Supplemental Information

This Document Errata reflects changes made on the datasheet for device 854S006I.

Revision History

BLOCK DIAGRAM

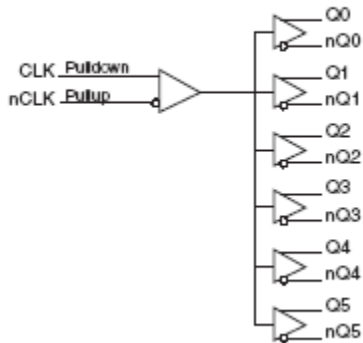
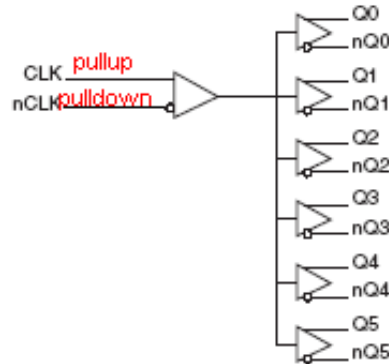
PAGE	DESCRIPTION OF CHANGE
Page 1	Block Diagram. Update Pullup and Pulldown of CLK and nCLK on the block diagram

BLOCK DIAGRAM
